MANDATORY UPDATE INFORMATION

Subject: Snap Rings Replacement — Mandatory Update

Product Group:	Date Issued:	Service Bulletin No. LT20140728		
Light Towers	08/08/14			
Bulletin Type		Models/Series Affected:		
X Mandatory		LT SERIES S/N 35167 AND HIGHER NOTE: Serial Number is last 5 digits of VIN located on		
Information Only				
Recommended Change	the	the A frame of the trailer (driver's side).		
Dotails

Figure 1. Location of Snap Rings

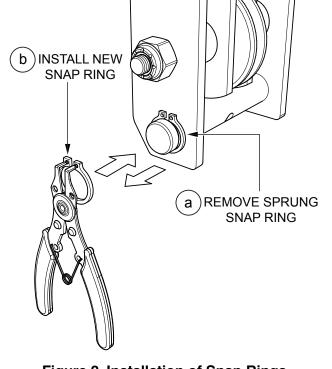
Problem: When the snap rings were installed on the line, the snap rings sprung. This is critical as the snap rings contain the pin that anchors the mast cable.

1. Inspect snap rings on both ends of the spring that anchors the mast cable on the light tower trailer. See Figure 1 for location of snap rings.

Solution: Replace snap rings. Failure to perform this procedure may result in damage to mast assembly and/ or damage to property or personal injury.

- 2. If snap ring is completely seated, replacement is not necessary.
- 3. If snap ring has sprung:
 - a. Remove the snap ring with a snap ring tool. See Figure 2.
 - b. Install new snap ring carefully with the snap ring tool. Ensure snap ring has seated completely within groove of pin. See Figure 2.
